January 30, 2006

Project Texas Roadhouse Madison, WI
Project # 20050922.2
Re Resubmittal: Urban Design Review

Please note the following revisions to the documents listed above:

FRONT (NORTH) ELEVATION

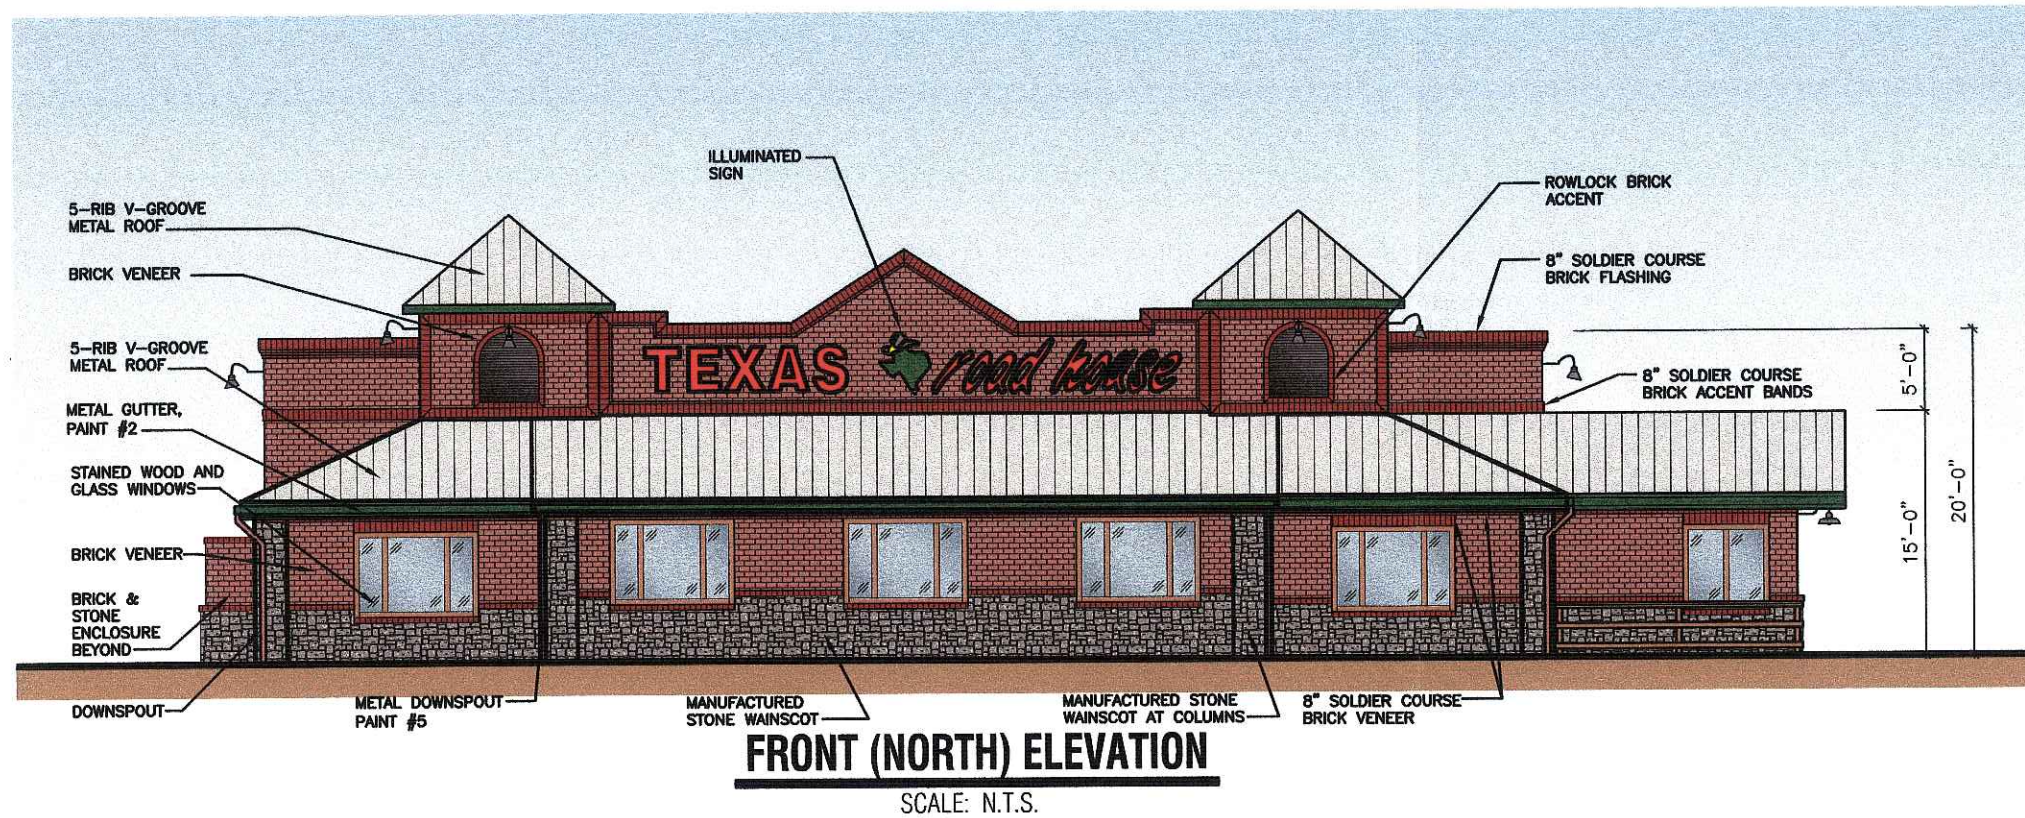
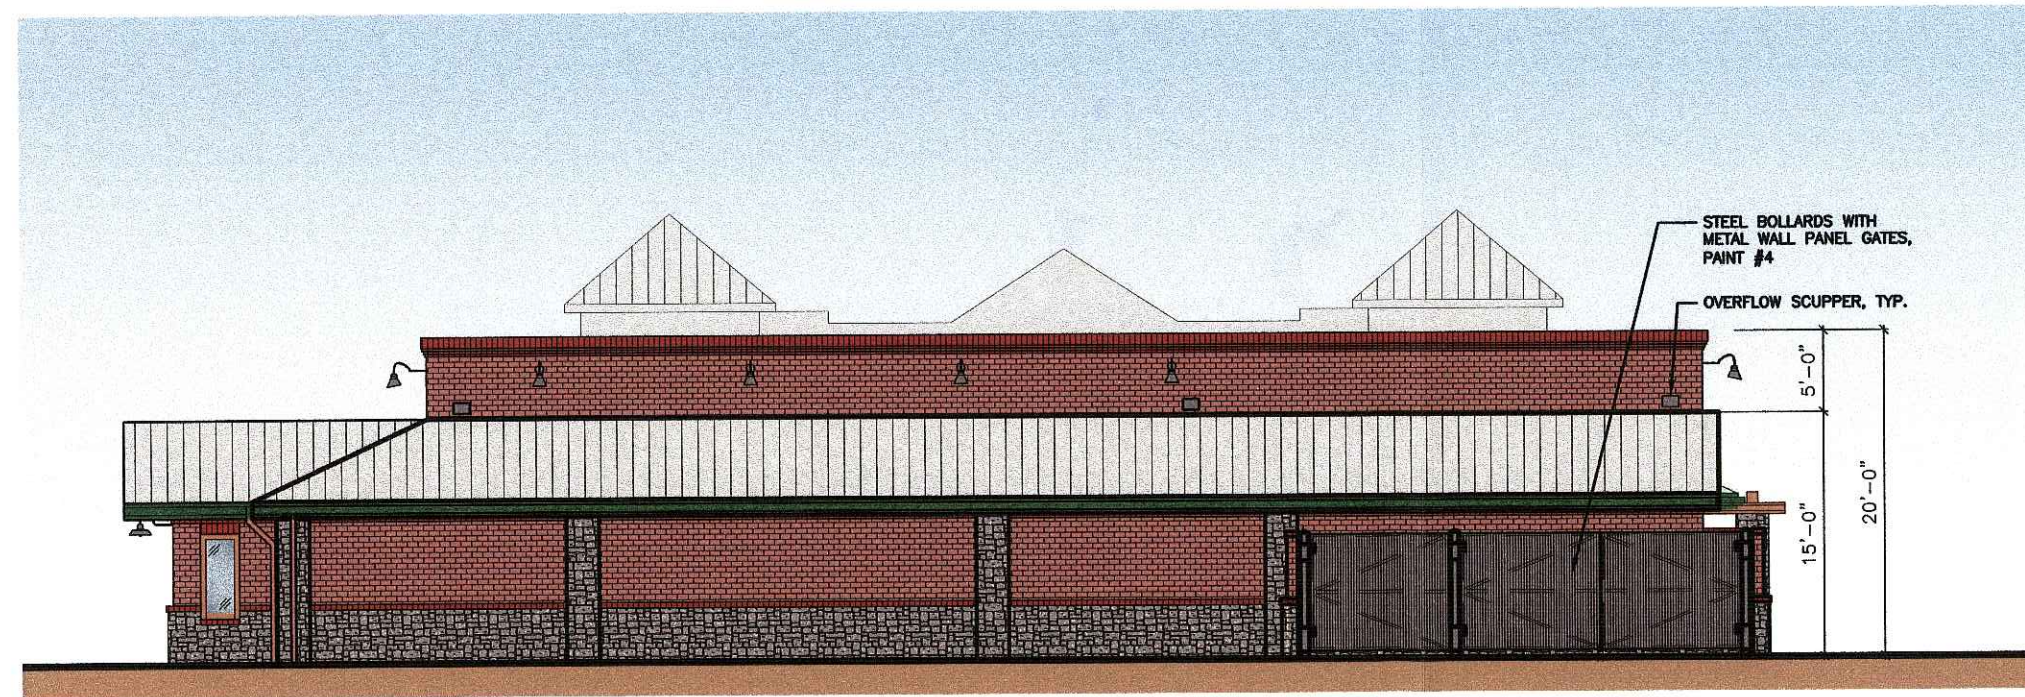
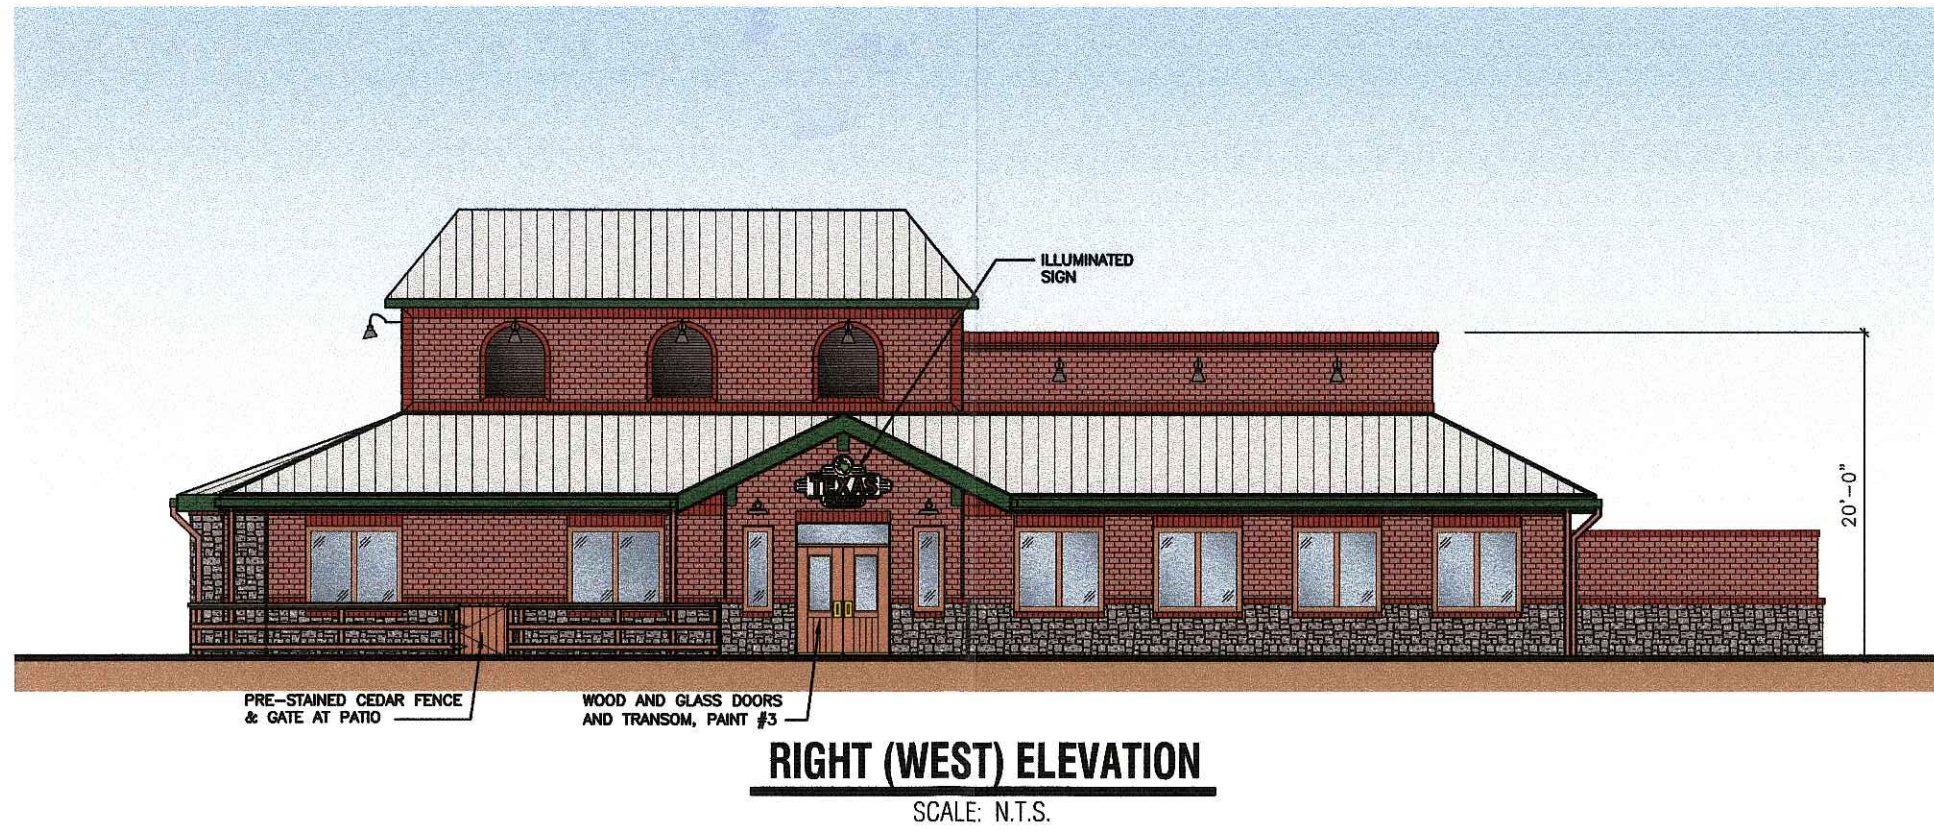
7. The architectural elevations have been revised to:
 - Remove the U.S. and State of Texas flags.
 - Incorporate full height brick with stone wainscoting.

- Incorporate architectural detailing such as accent banding, soldier courses and a trellis type structure along the east elevation.
 - Incorporate additional casements within the windows along the west elevation.
